Phillips Planning Services Ltd.

Replacement Dwelling at 115 Frognal Ref: 2016/5380/P

Our clients object to the current application for the following reasons.

Proposed site plan showing additional footprint and the loss of the gaps with the plot filled to physically join the south boundary with No. 113 and the garage block to 113 and 1 Oak Hill Way

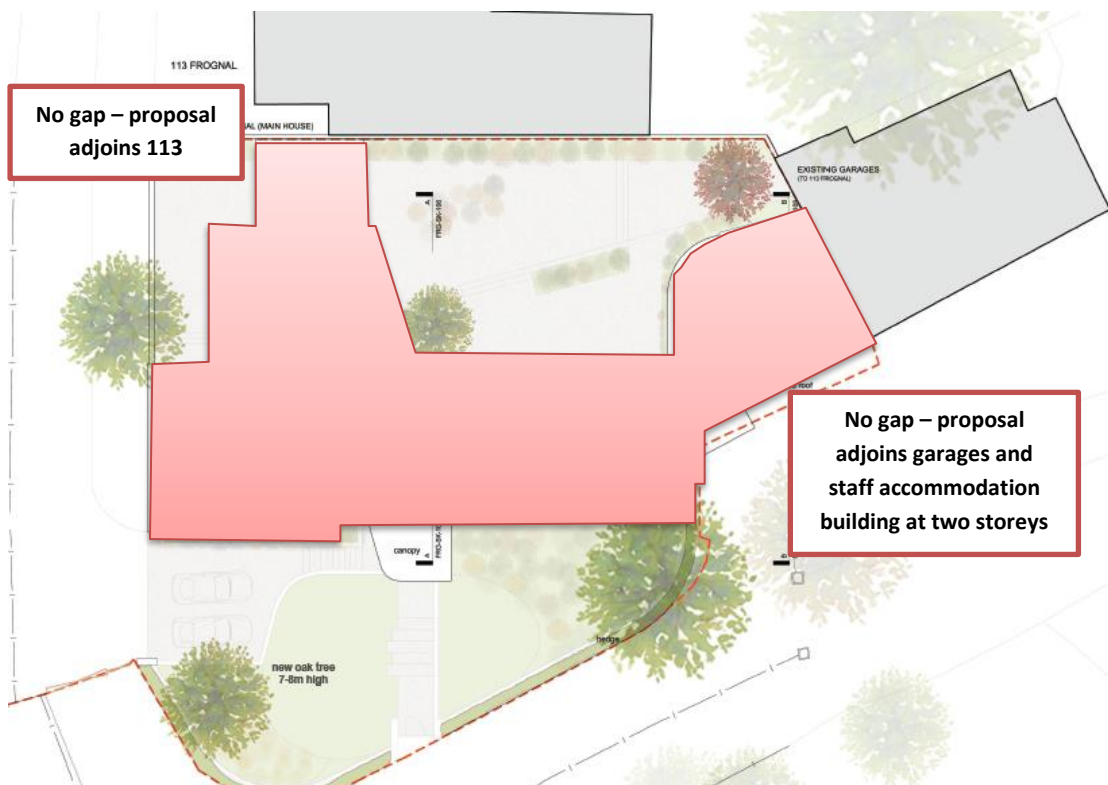
- It would be unreasonable to suggest that the proposal could be categorised as “conservative and highly contextual”. It is not and it would appear wholly out of character with its surroundings.
- Similarly, the design of the proposal cannot be considered “a piece of exceptional contemporary architecture”.
- The proposal disregards the identified open character of the site and the advice that by “filling it in could result in **harm** to the character and appearance of the conservation area.” The design does ‘fill’ the site completely joining our client’s property at No. 113 all the way through to 1 Oak Hill Way as shown.

It is considered that the 'filling' of the site in this way is out of character and represents overdevelopment. This is particularly the case given the largely two storey nature of the additional built form.

View along the lane showing proposed new side driveway / parking

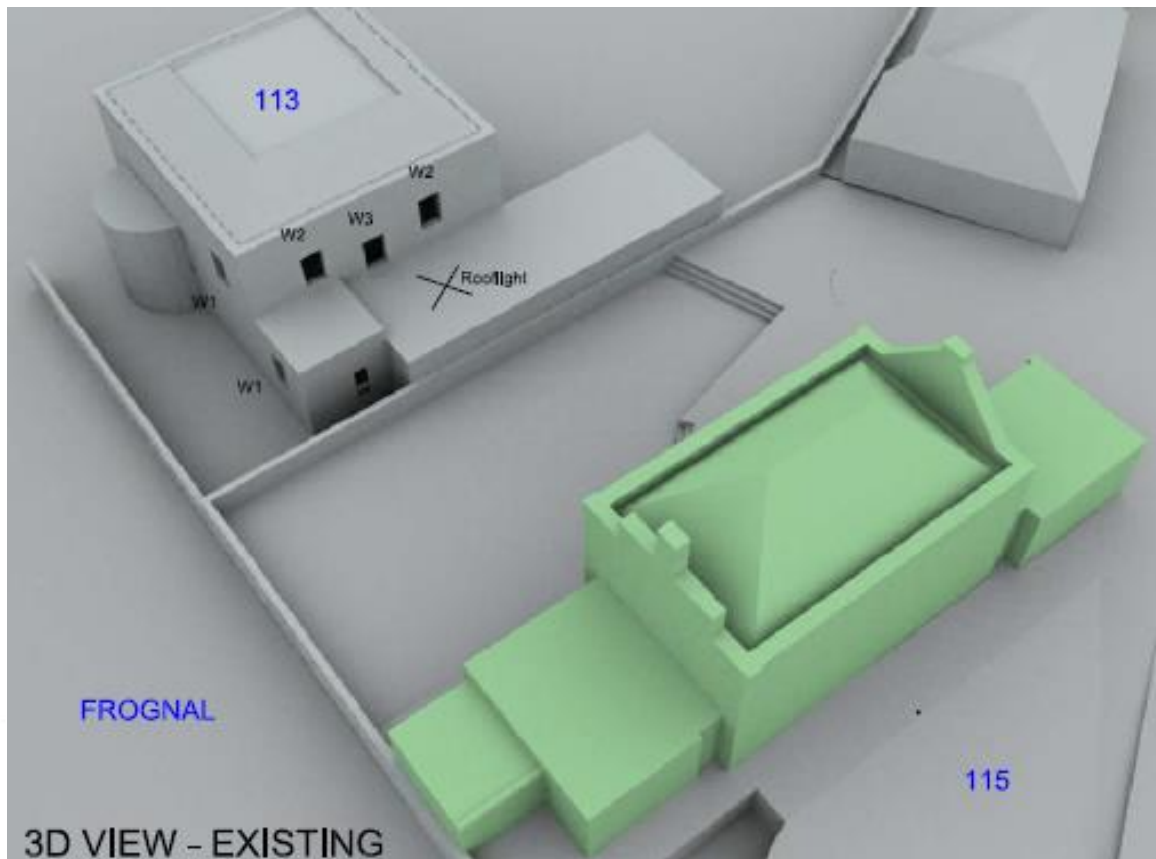
Related to the tree removal, and as set out above it is noted that the submitted plans provide for a new parking area at 115 to be accessed from the lane which serves the houses which face east onto Froggnal including our clients.

This is a quite a quiet, characterful, rural lane as shown below which would be harmed through the provision of a new driveway access onto it. Our client also holds concerns regarding the safety of vehicles backing out onto this lane with no visibility.

Proposed relationship with development directly adjoining the boundary.

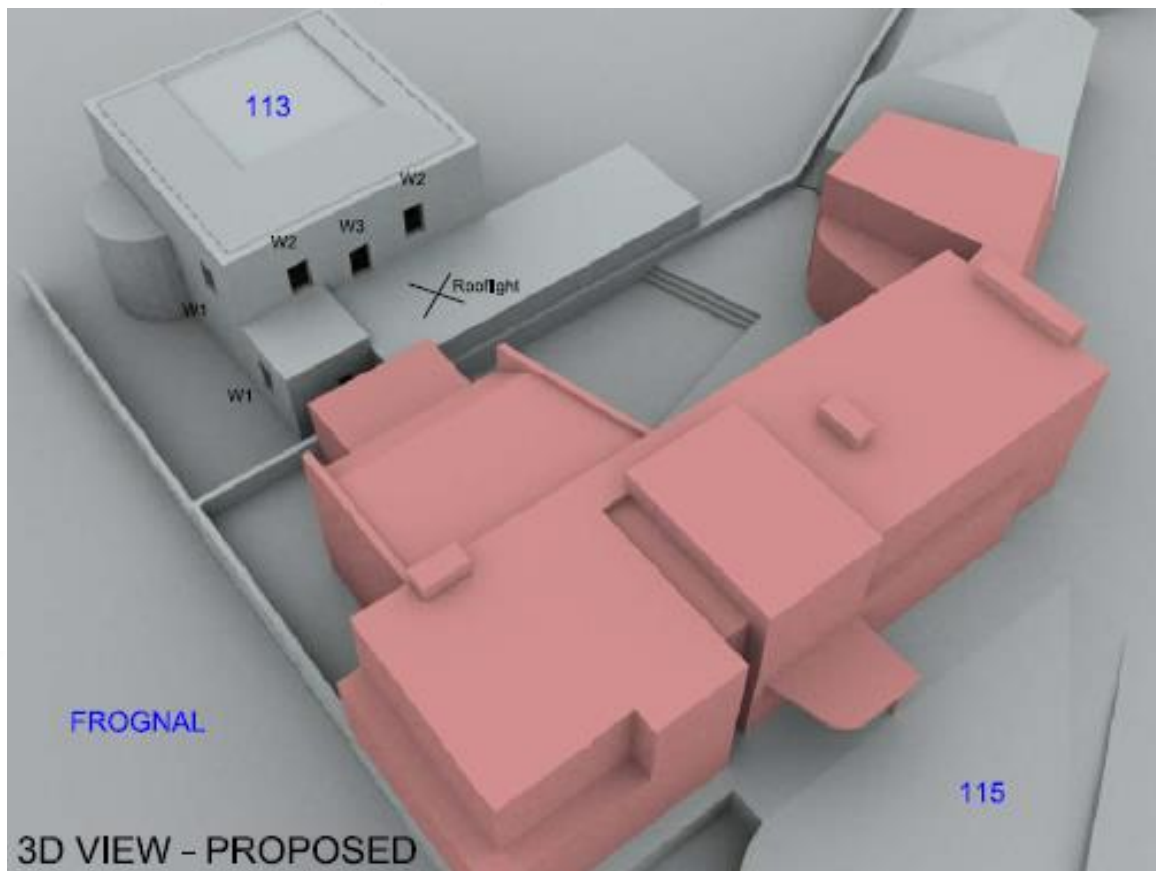
As is apparent from the existing drawings (and site view), the rear of No. 115 currently stands some 12 metres from the boundary with our client's property No. 113. This provides a sense of space and is part of the amenity enjoyed by No. 113 i.e. our clients do not currently feel dominated and oppressed by neighbouring built form. The relationship is perhaps best emphasised by reference to the 3D modelling which has been included within the submitted daylight, sunlight and overshadowing report.

There is absolutely no need to propose such an obviously overbearing and intrusive extension such as this. The proposed property would still be of significant scale without this rear element added. This represents overdevelopment of the plot, the result of which is that it unreasonably impinges upon and creates an overbearing impact on 113.

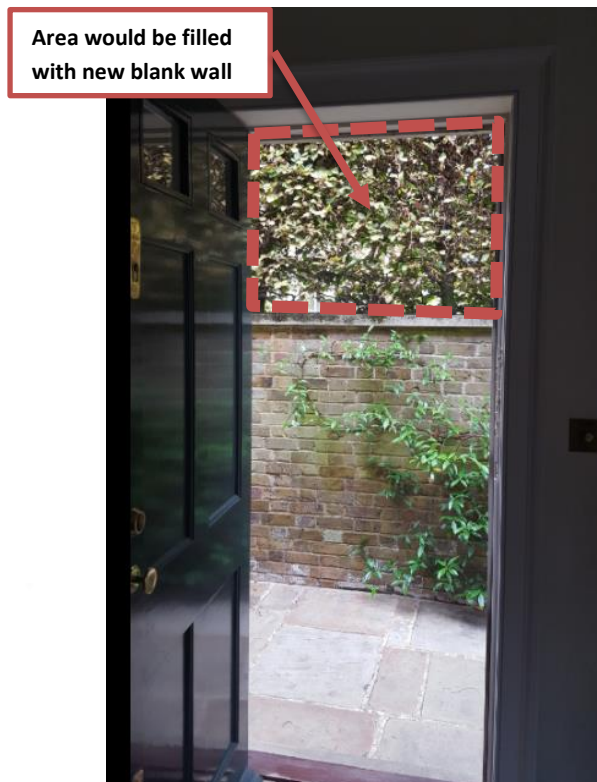
As will be noted from the 3D model, two windows are shown in the ground floor single storey element of 113. These are termed W1 and W2 in the light report and are circled opposite.

However, W2 is not a window it is in fact the main door to the property. This is used every day by our clients when entering and leaving the house.

The report also omits any reference to our clients oval window which again we highlight the position of opposite.

The light report acknowledges that W2 (albeit said to be a window rather than a door) fails the BRE light assessment test with around 60% of its vertical sky component (vsc) lost as a result of the proposal. The report rather dismissively however suggests that this should not be seen as problematic as it's secondary window to a non habitable room.

East elevation as existing with new mass / bulk shaded grey and front door noted red

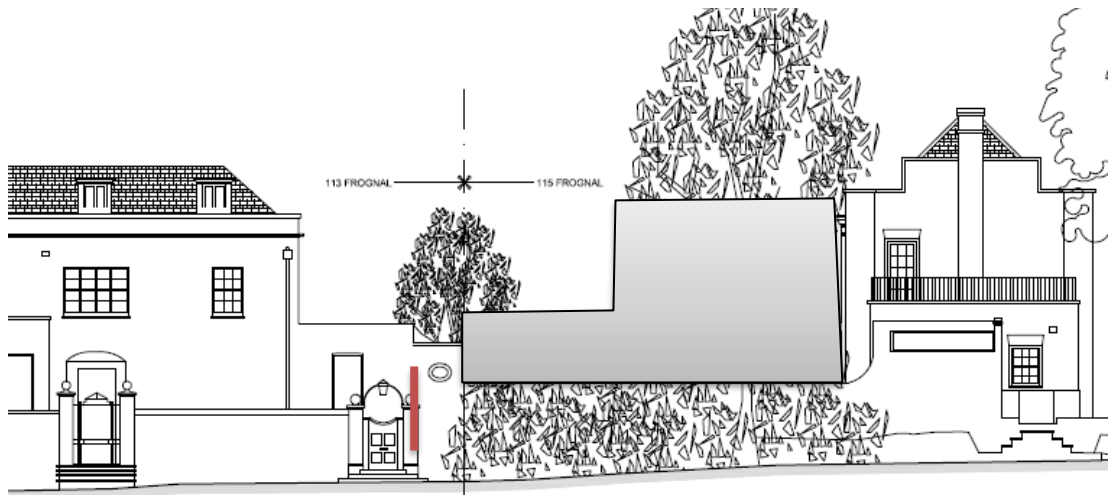
There is very little to say in respect of this element other than it is simply a matter of fact that this relationship is so clearly detrimental to our clients that no reasonable case can be made that permission could be granted for it.

New massing at two storey level projecting toward 113.
5 metres from boundary, 10 meters from window

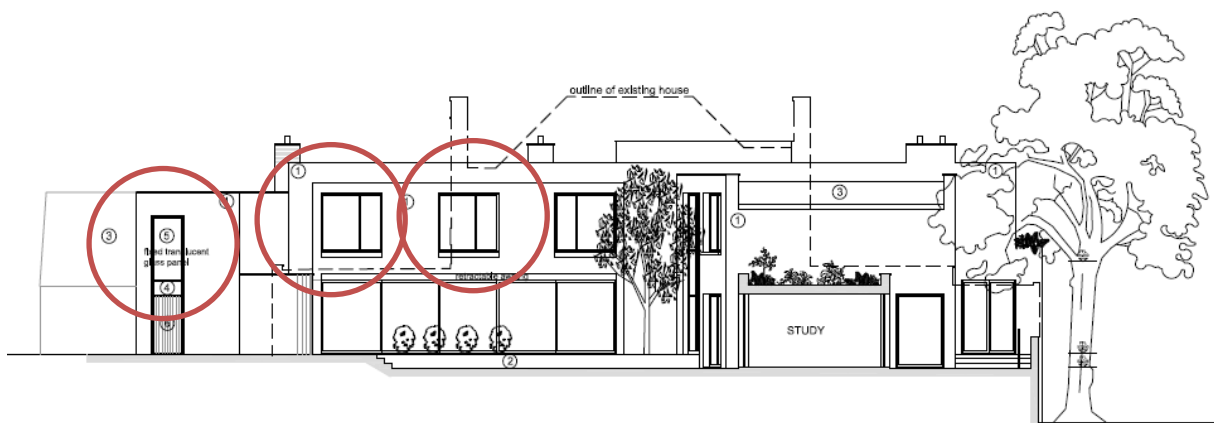
In addition to this ground floor relationship we also raise concern over the significant bulk and proximity of the proposed first floor projection to our client's bedroom window.
